STAFF RECOMMENDATION
2410 Oakland Avenue
February 17, 2016

Application: New construction-outbuilding (detached accessory dwelling unit)
District: Belmont-Hillsboro Neighborhood Conservation Zoning Overlay
Council District: 18
Map and Parcel Number: 10416028300
Applicant: Van Pond Architect, PLLC
Project Lead: Paul Hoffman, paul.hoffman@nashville.gov

<p>Description of Project: Construction of a detached accessory dwelling unit (DADU) at the rear of the lot.</p> <p>Recommendation Summary: Staff recommends approval with the conditions:</p> <ol style="list-style-type: none">1. The trellis over the walkway is reduced to no wider than six feet (6') across;2. Staff approve the final details, dimensions and materials of windows and doors prior to purchase and installation;3. Staff approve the roof color and masonry color, dimensions and texture; and,4. The applicant file a restrictive covenant acknowledging that the structure is being established accessory to the principal structure and may only be used under the conditions listed by Code. <p>With these conditions, Staff finds the project meets sections II.B of the design guidelines for the Belmont-Hillsboro Neighborhood Conservation Zon

Figure 1. 2410 Oakland Avenue

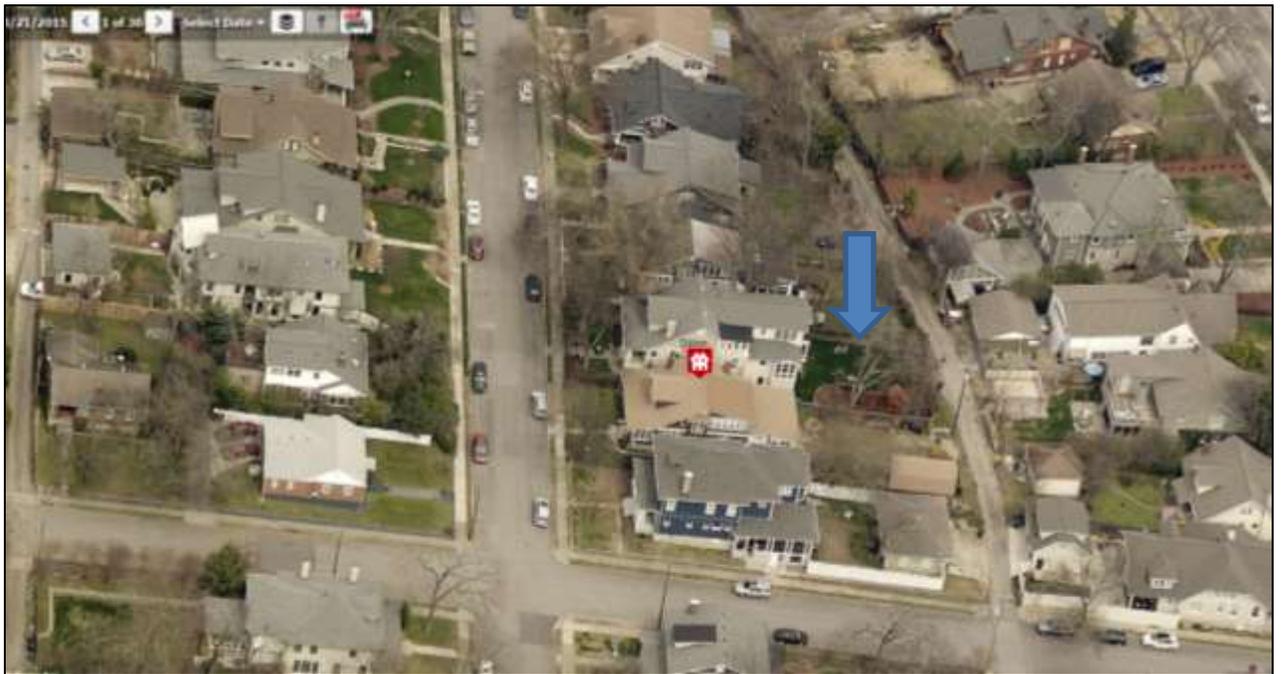
Background: 2410 Oakland Avenue is a contributing building constructed circa 1915 in the Belmont-Hillsboro Neighborhood Conservation Zoning Overlay.

① Proposed Main Floor Plan

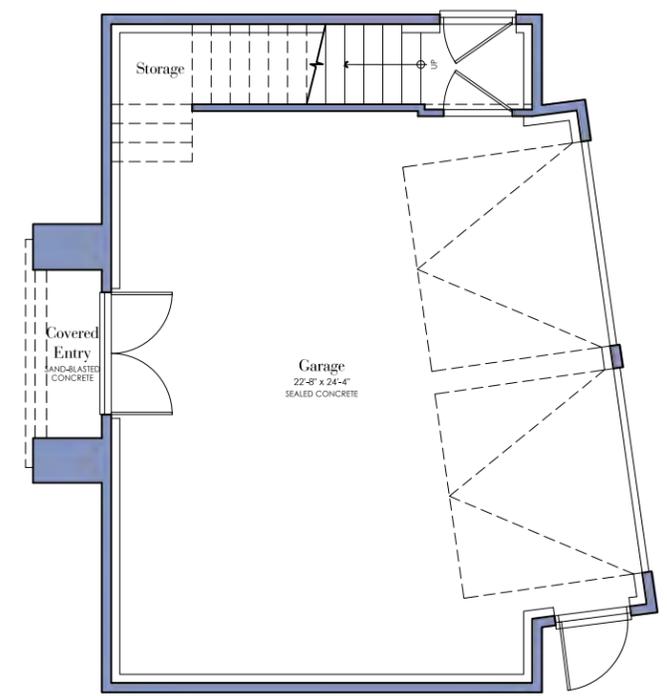
Please see attachment A for Staff's full review. The proposed new outbuilding will be accessed via the alley. It is a two-

story structure with a footprint of six hundred and fifty-three square feet (653 sq. ft.). The lot is more than eight thousand square feet (8,000 sq. ft.) so a structure up to seven hundred and fifty square feet (750 sq. ft.) is permitted. The outbuilding is subordinate to the house in overall height and eave height.

① Proposed Garage Elevation Facing House

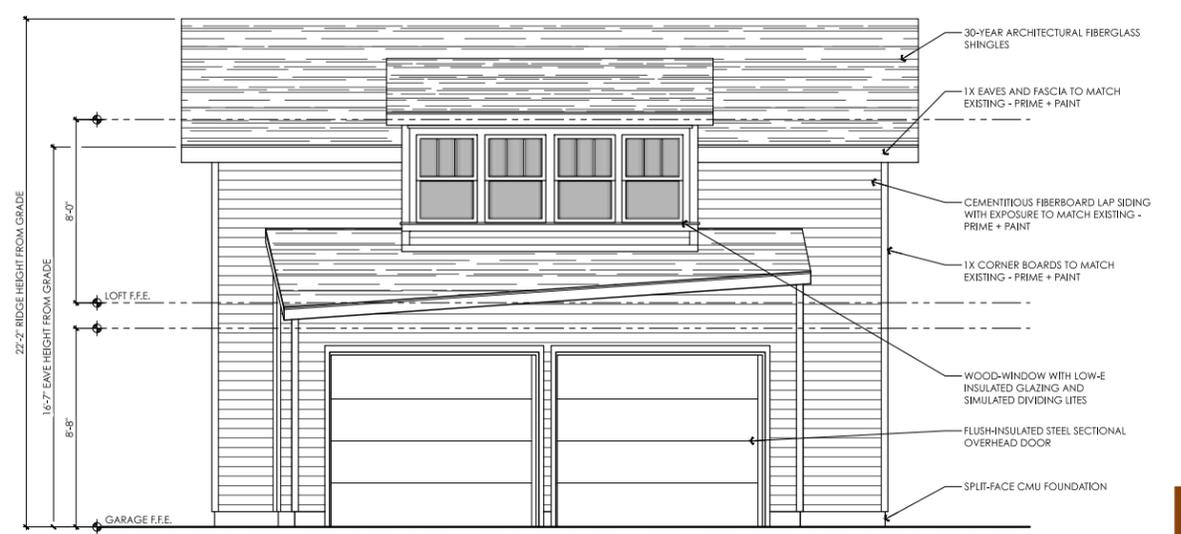
The proposed materials have been approved by the Commission, and include fiber-cement siding with a reveal matching that of the house, wood windows, architectural fiberglass shingles, stone veneer, and split-face concrete block foundation. Staff requests final approval of the windows, doors, masonry, and roof color. The walkway from the house to the outbuilding has a nine-foot (9') wide trellis over it; the Commission has approved recent coverings no wider than six feet (6') to assure that the outbuilding is not "attached" to the existing house. Staff recommends a condition of approval that the trellis be reduced in width to no more than six feet (6') across.

1. The trellised walkway is reduced to no wider than six feet (6') across;
2. Staff approve the windows and doors;
3. Staff approve the roof color and masonry; and,
